SERVICE No. 216 BULLETIN

Piper Aircraft Corporation

SUBJECT: Fuel Cell Drain Modification

MODELS AFFECTED: PA-24 and PA-24 "250" Comanches, Serial Numbers 24-581 to 24-3495 inclusive

Tube 1/4", Serial No. 24-581 to 24-1197
 size 1/2", Serial No. 24-1198 to 24-3495

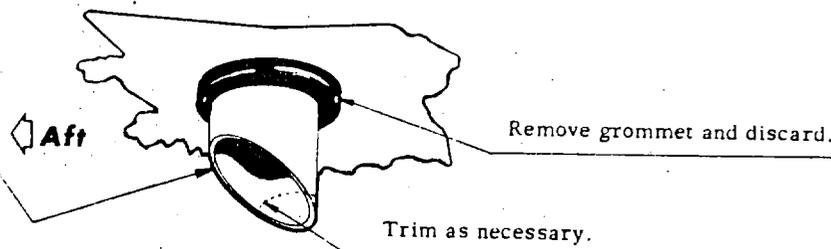
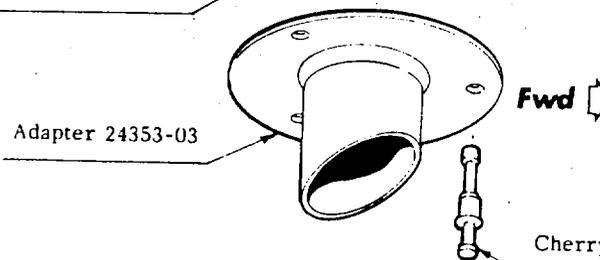
Reports of fuel cell collapse in the Comanche have been received from the field. This collapse is basically due to loose fuel cell caps and a negative pressure in the fuel filler neck area created by the rearward scarf on the fuel filler neck drain tube.

Kit 756 756 has been developed to change this negative pressure to a positive pressure by facing the scarf forward.

PA-24 and PA-24 "250" Comanches, serial numbers 24-581 to 24-1197 inclusive, have a 1/4" fuel drain line and serial numbers 24-1198 to 24-3495 inclusive have a 1/2" fuel drain line. Kit 756 756 is adaptable to both types. See sketch on the reverse side of this bulletin.

Do not enlarge hole in gasket for
 1/2" tube as it will stretch over
 tube.
